STATE OF MARYLAND WELL COMPLETION REPORT

RE: Replacement Well Testing

From: Williams, Jeffrey <jewilliams@howardcountymd.gov>
Sent: Tuesday, January 23, 2024 12:04 PM
To: John Carney (jcarney@bei-civilengineering.com) <jcarney@bei-civilengineering.com>
Subject: 6707 Hitching Post

RE: Replacement Well Sampling & Abandonment
Elizabeth & Noah Green
6707 Hitching Post Court
Clarksville, MD 21029
Well Permit # HO-18-0104

PLAN VIEW

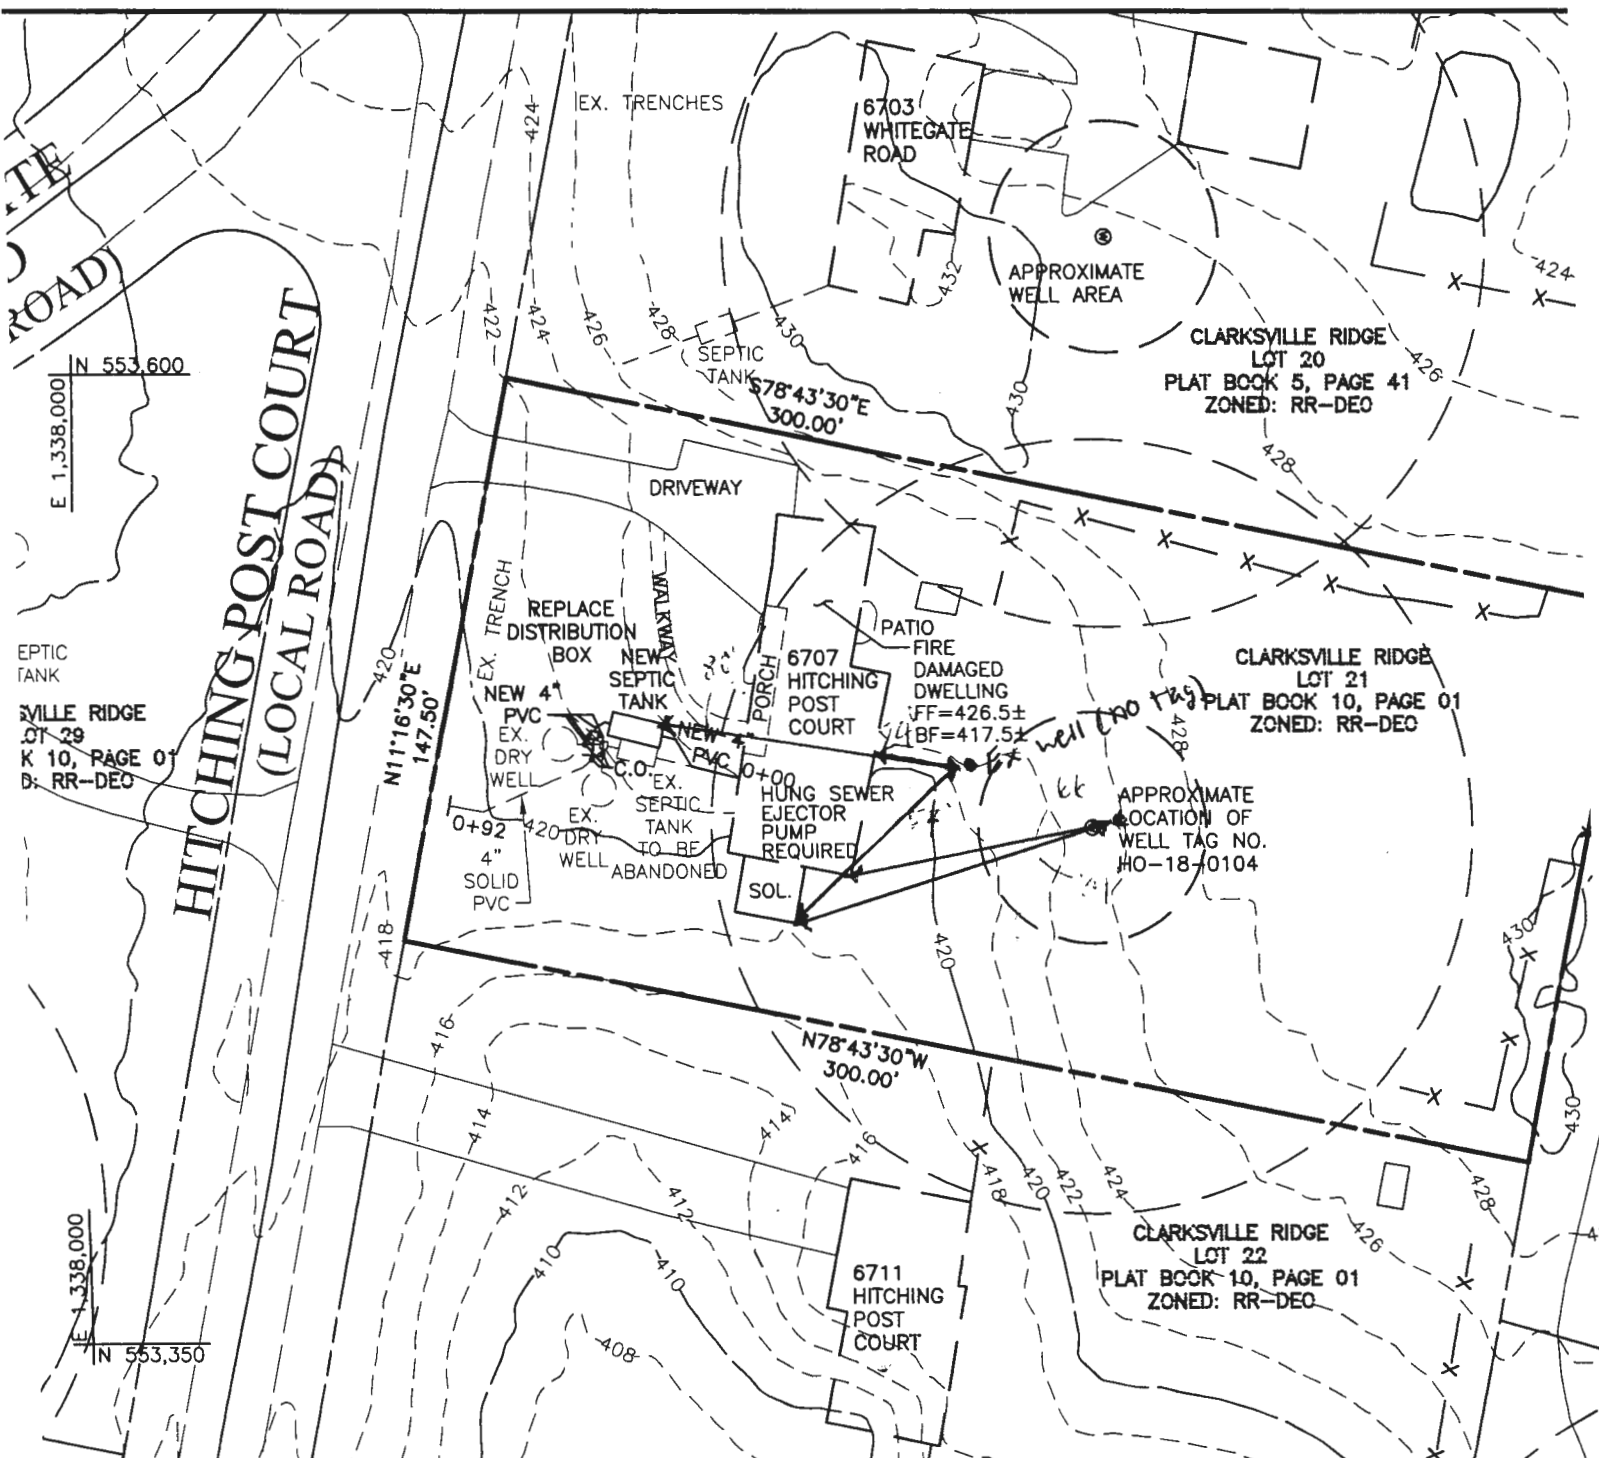
Jeff, thank you for reaching out. So when I was reviewing the lot file I noticed that it did not direct the contractor to abandon the dry wells and the diagram shows lines from the Distribution Box to them. I looked at the instant street view and I can see three cleanouts. This makes me think they were not abandoned and are still in place, providing whatever disposal the soils allow.

I was a little concerned about the new distribution box elevation. We are now raising the distribution box to 419.5 and existing grade above the lower dry well is 421.0. I still think that if the dry well is full the flow would be 100% to the trench and not out of the ground above the dry well, the dry wells are deep. That is assuming the dry wells weren't abandoned.

I hesitate to remove them if they are still there and connected because they could be providing some disposal capacity, especially the left one. I wish I had more info regarding the failure. Give me a call to discuss.

Hi John. I looked at the OSDS plan you submitted for this property. You don't label the two drywells as to be abandoned. I'm wondering if that is your plan or trying to keep them? I'm assuming they're not functional since they did a repair in '00 to add the trench. Also, do you know if their plan is to rebuild pretty much the same house as was there before? I don't think I heard back from the owners on what they wanted to do.

Hey John. We came across an issue with this property when we were out with the contractor for the tank replacement. There is an old well not shown on the design plan that is tied in with the 18 tag well. The old well is about 24' straight off the back middle of the house, which puts it about 80' from the proposed tank and about 90 feet from one of the drywells. There are a couple things you can do about it to move forward:

1. You could propose to abandon and seal the old well and proceed with the site plan
2. You could request a variance from MDE for the distance from the old well to the components. I'm not sure whether they would approve it, but these are existing conditions. This would be a variance form signed by the homeowner. A blank copy is attached.
3. We can't just abandon one of the drywells because I think both are needed for capacity. The only other thing on the septic side would be to do perc testing to do a whole new drainfield.

Hi John. I tried to call but your voicemail was full. We asked MDE for guidance on this one, which caused the delay. They are onboard with us not requiring establishment of repair area before approving the addition as shown. They are also ok with us leaving the drywells as long as there is capacity. They even said that replacement of the septic tank is recommended, but not required. I think we discussed that the owners wanted to replace to make sure they were ok. We would recommend that the drywells be filled with stone and vertical perforated pipe if they still have capacity. If we find them full, we will want them abandoned. I can add notes to the OSDS plan to that effect.

Jeff, thank you for reaching out. I think we will be working with the owners to submit a variance request. The 18 well yielded 0.81 gpm when it was drilled. I assume they left the old well and used it in tandem to achieve 1.0 gpm. I've added the well location to the plan. I will cover the steps with the owners and get the sampling done as soon as possible. Thanks, John
